Project Name: Mt. Hope School – New BuildProject No.: 221125-140Architect: C2AEDate: 7/31/2023Bid Package No.: 2Bid Due Date: 08/03/2023

Addendum 3

Project No.:	22-0116	Date:	July 28, 2023
Project:	Mt. Hope Lansing School District SB-1785 Ingham County, MI	A/E Firm:	C2AE
Owner:	Lansing School District 519 West Kalamazoo Street Lansing, MI 48933	Project Manager:	Steve Jurczuk

FIRST LEVEL LIGHTING PLAN - AREA A
1/8" = 1'-0"

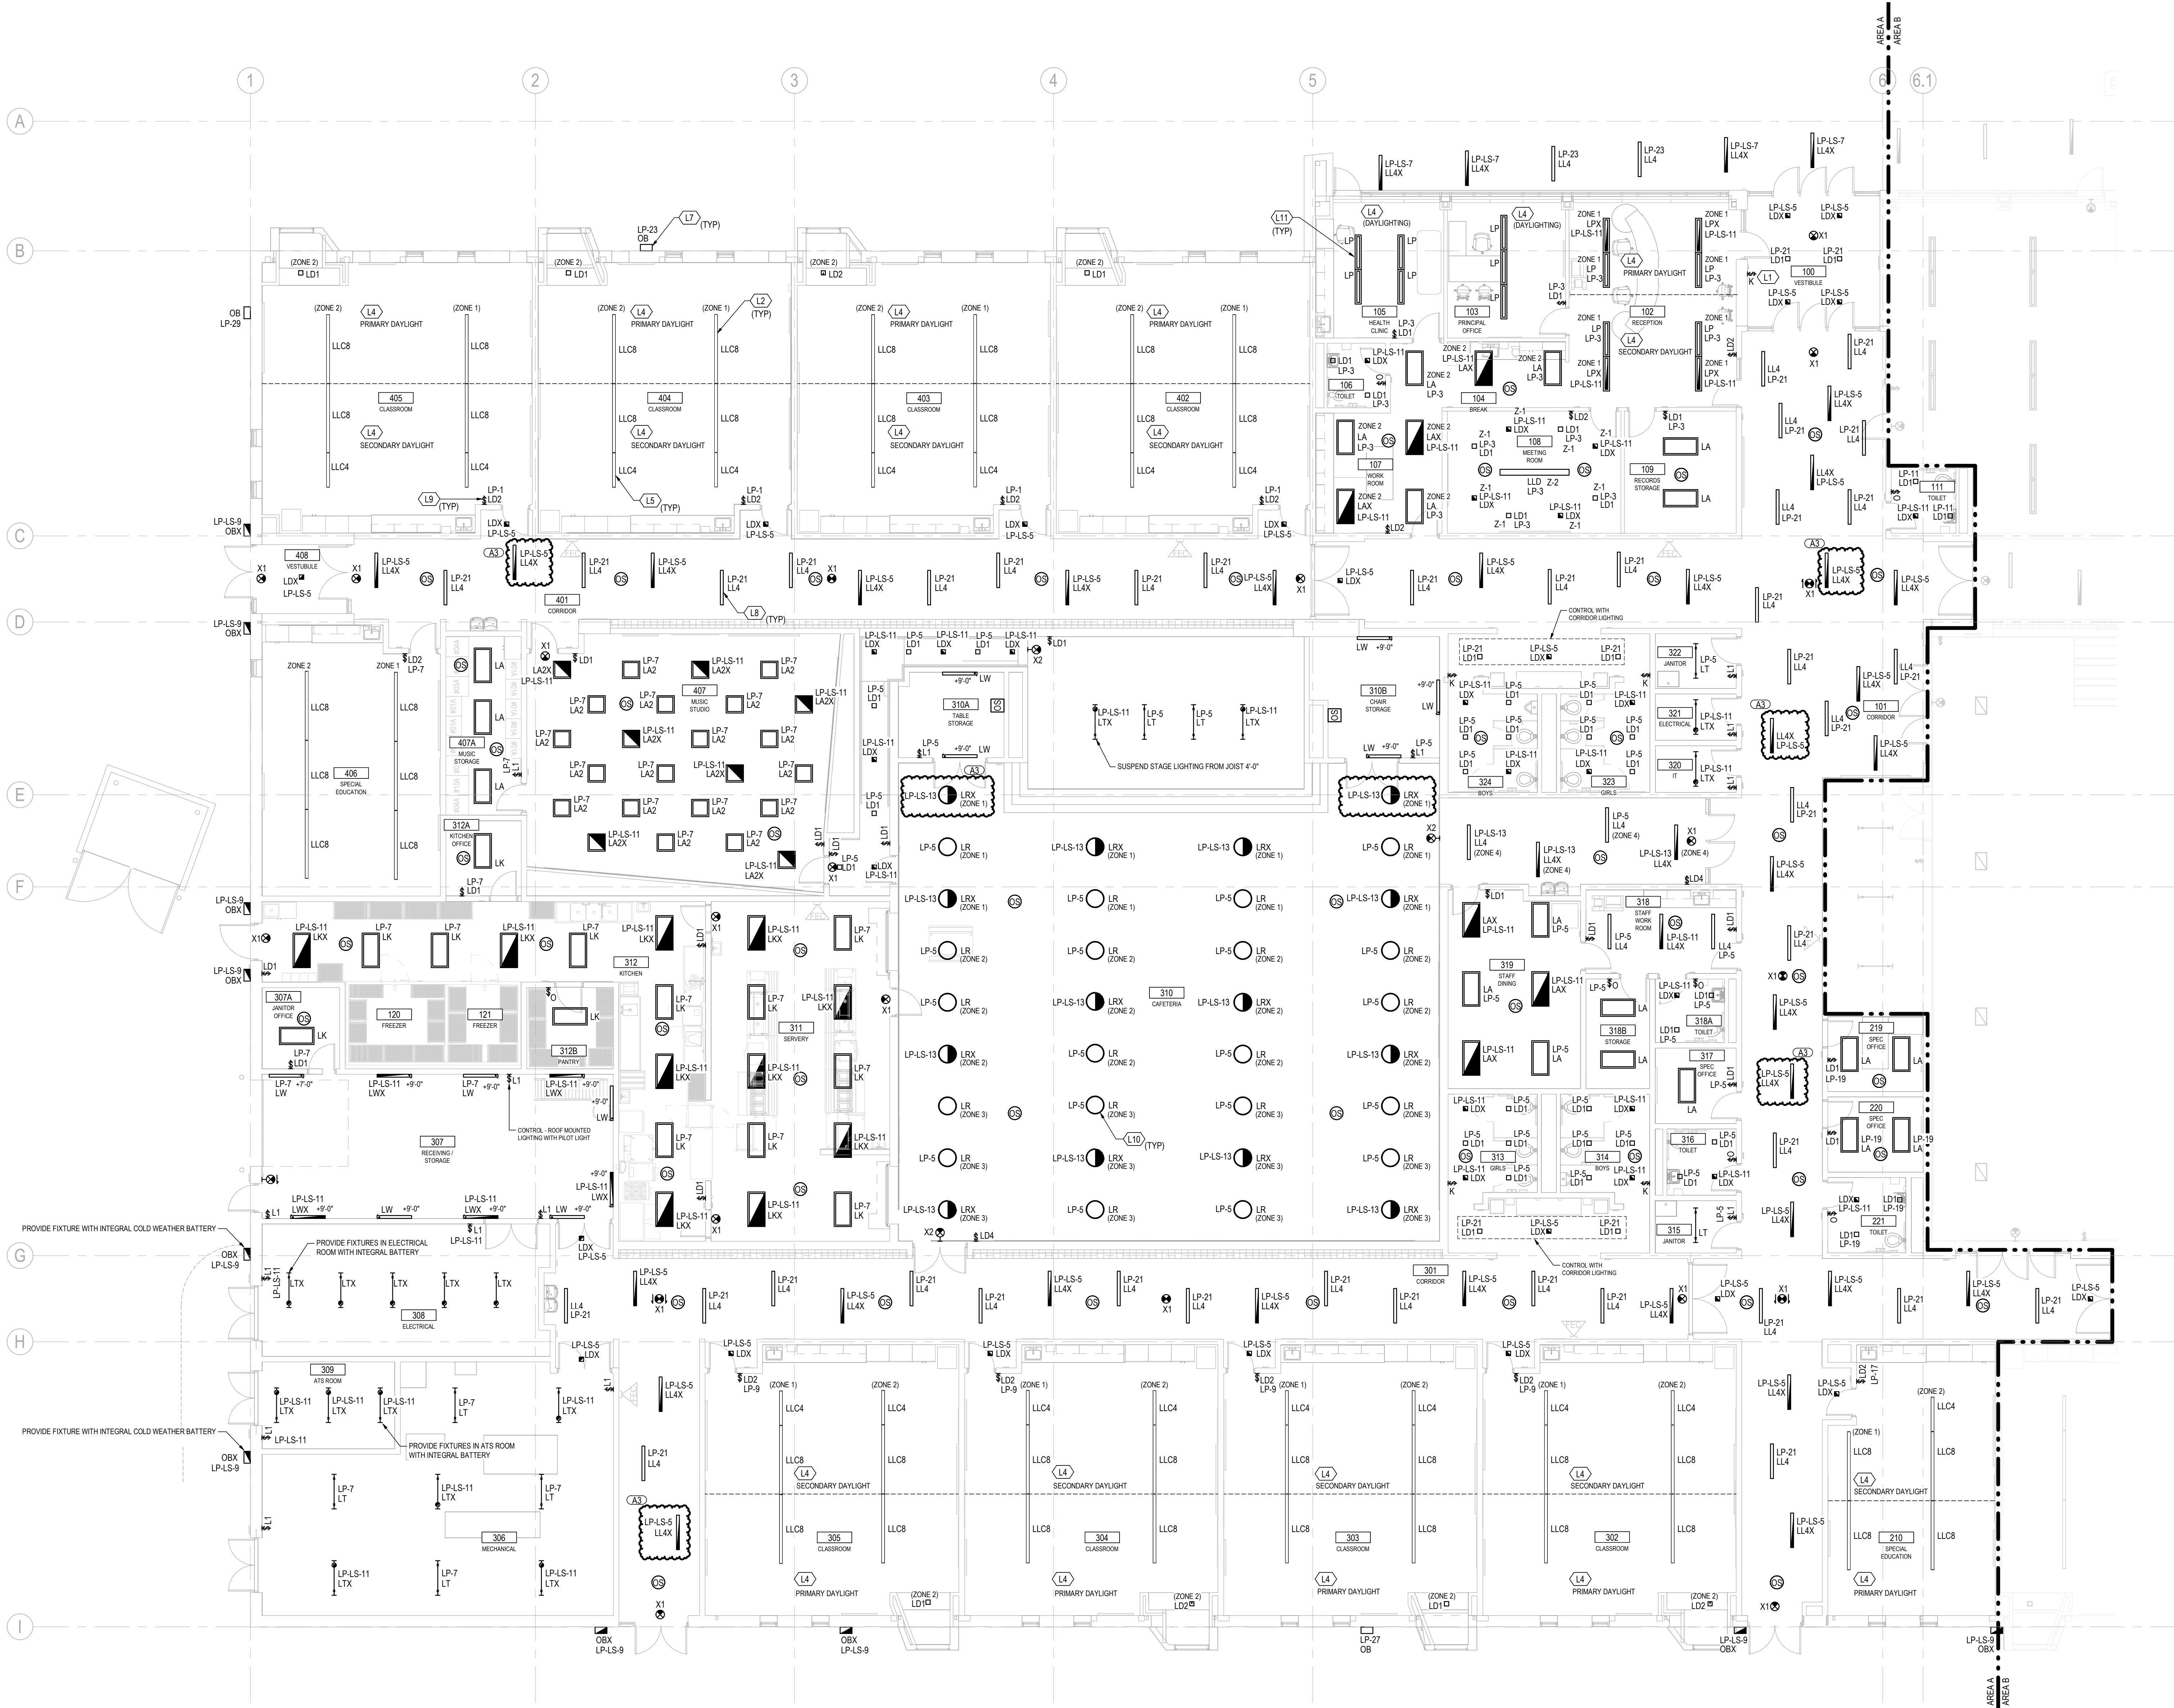
- A3.31 Refer to Sheet E-111A (reissued):
Added select light fixtures to generator as indicated for egress lighting.

ENLARGED MAIN ELECTRICAL AND BOILER ROOM
1/4" = 1'-0"

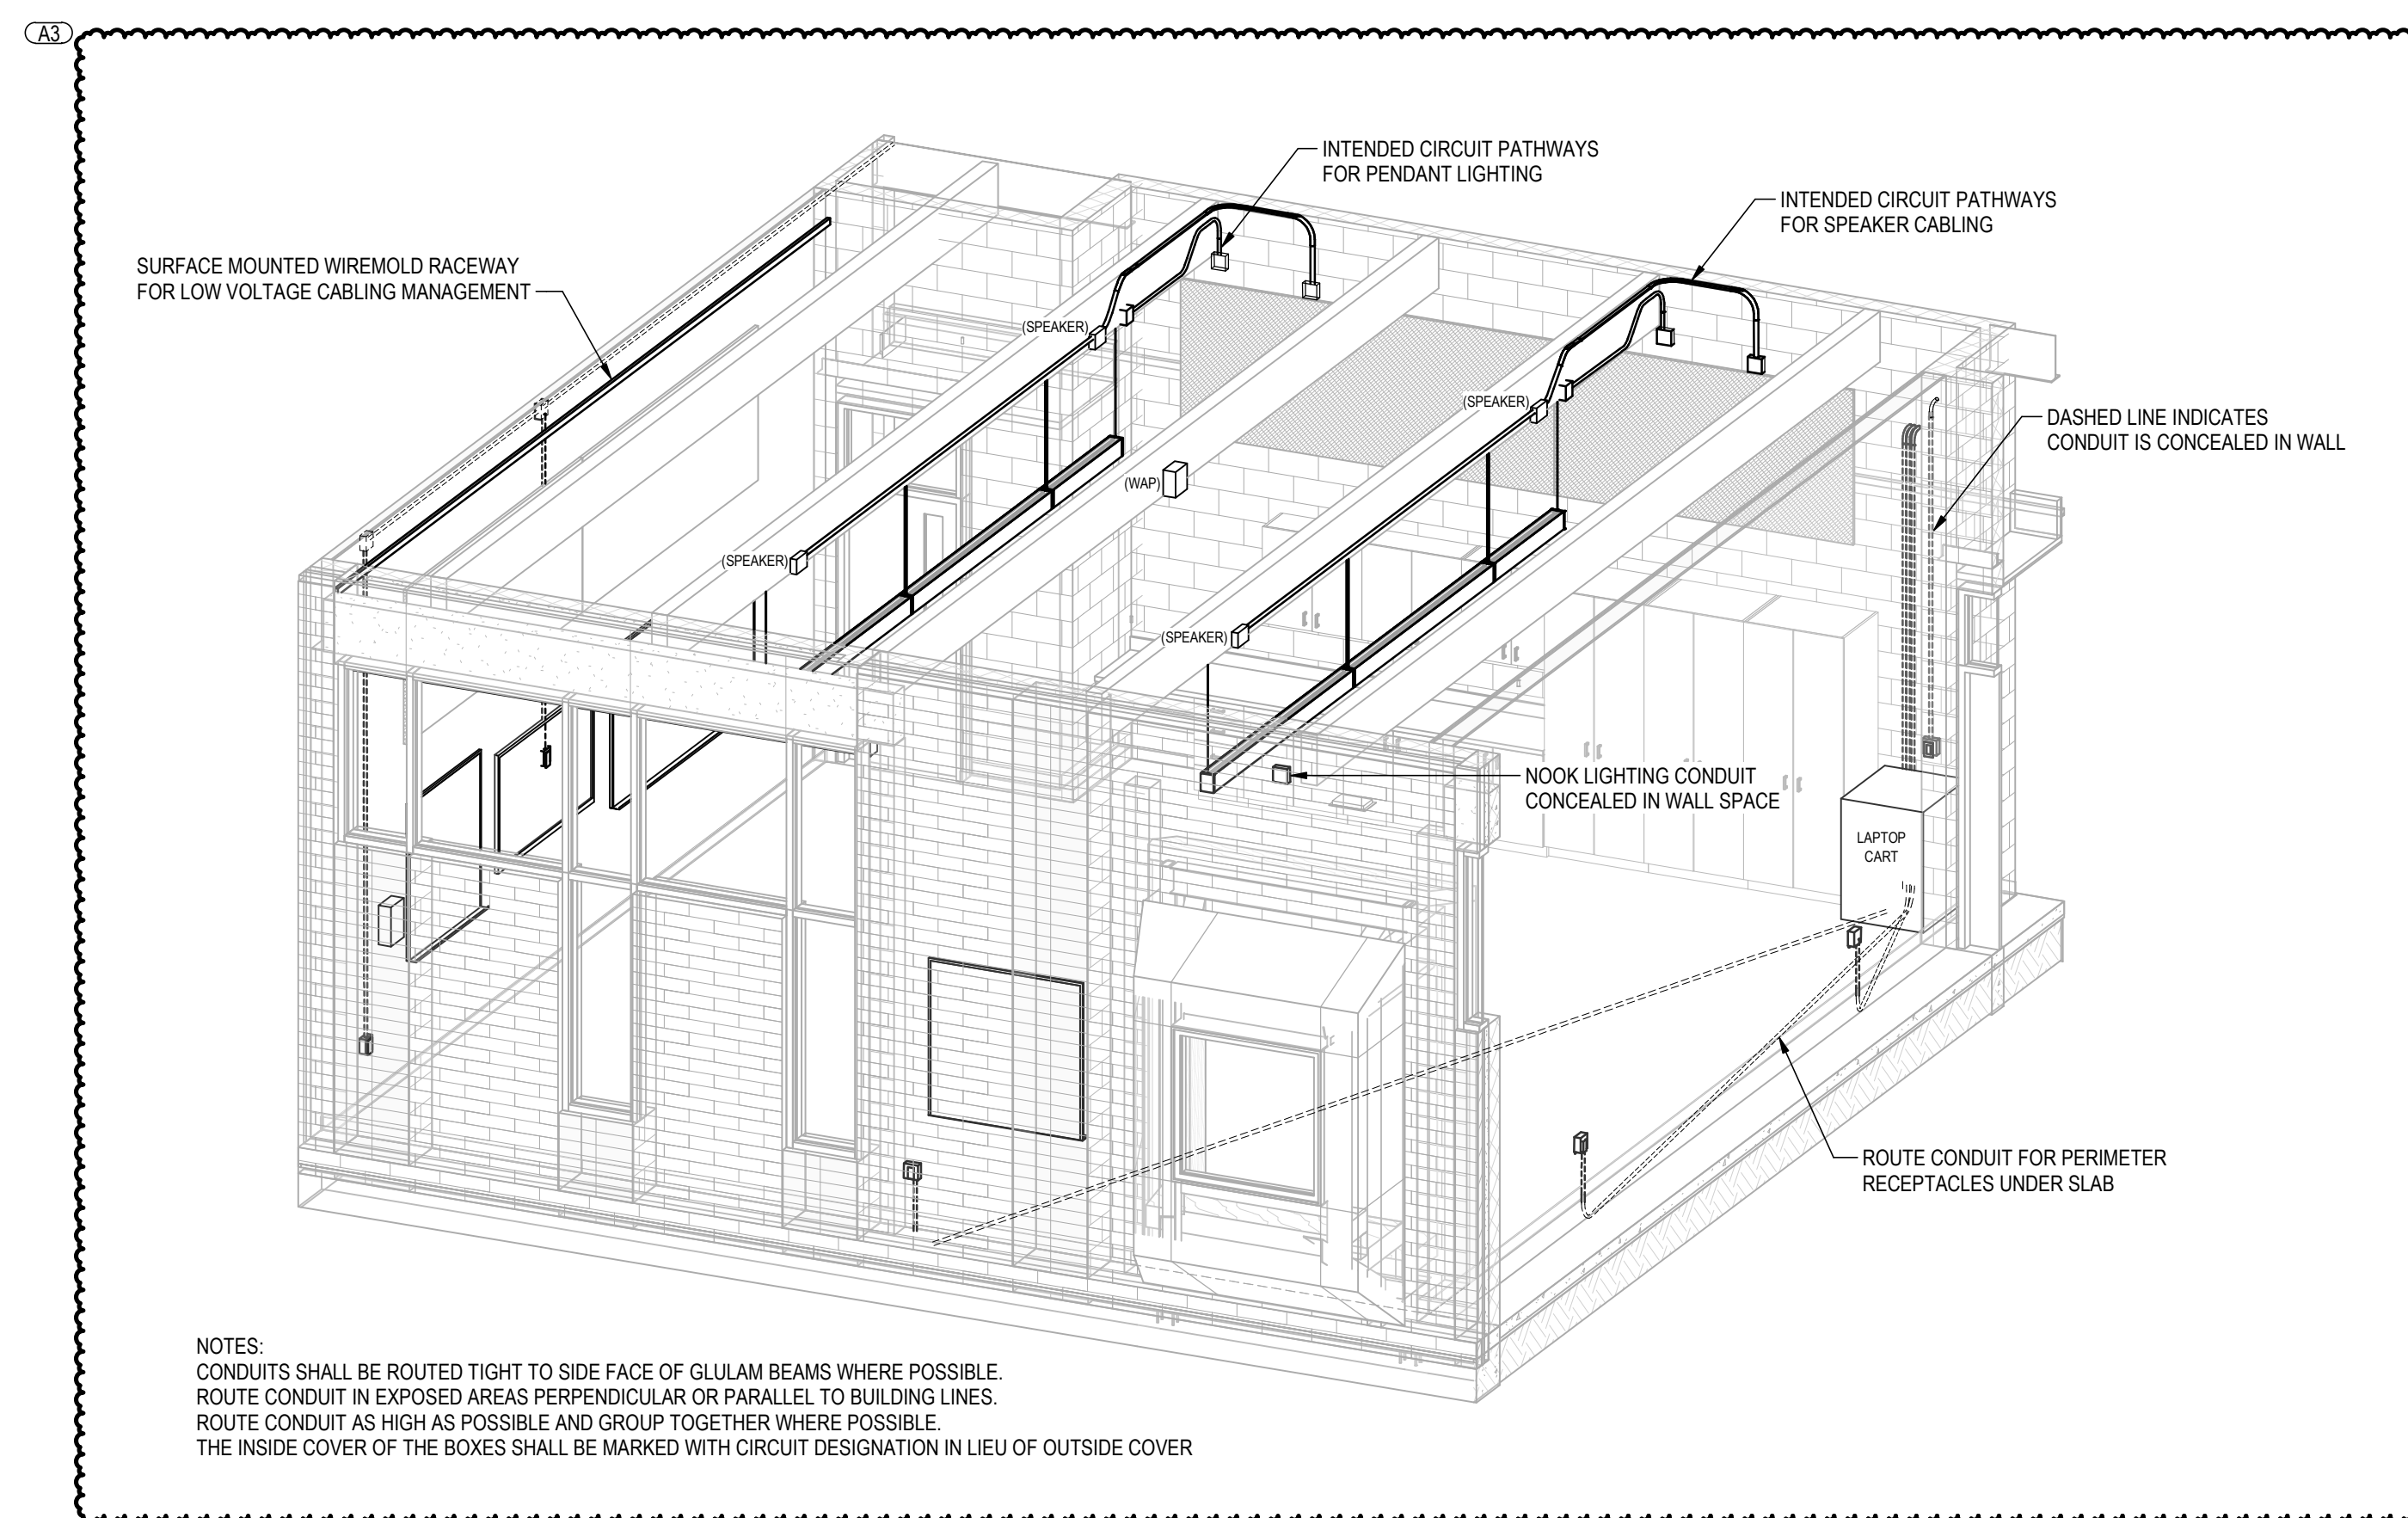
1. Revise layout of generator and medium voltage transformer.
2. Add 2000A CT Cabinet.
3. Clarify equipment concrete pad requirements.
4. Add power for DWH-1 and DWH-2.
5. Revise detail for typical classroom conduit routing.
